SIB 61 01 20  
ACCESSORIES DO NOT POWER ON

E-Series	Model Description
F95	X5 M SAV (Sports Activity Vehicle)
F96	X6 M SAC (Sports Activity Coupe)
G05	X5 SAV
G06	X6 SAC
G07	X7 SAV
G20	3 Series Sedan
G29	Z4 Roadster

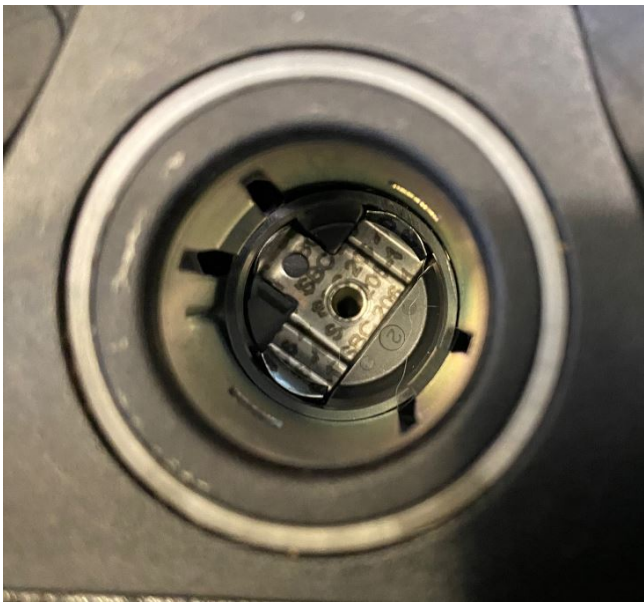
2. Loosen the Torx bolt using a T10 bit driver. DO NOT apply too much downward pressure as this can cause the power socket to come apart underneath.

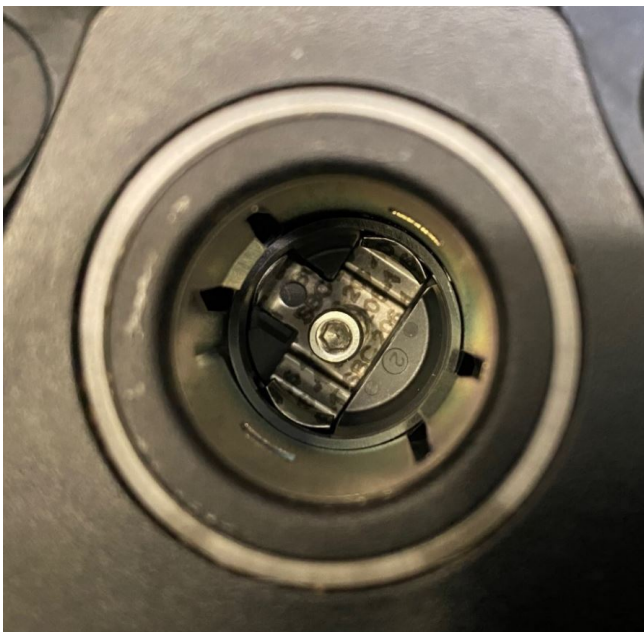
3. Remove the Torx bolt.

4. Insert the replacement bolt and hand tighten (McMASTER-CARR, item number 91292A112).
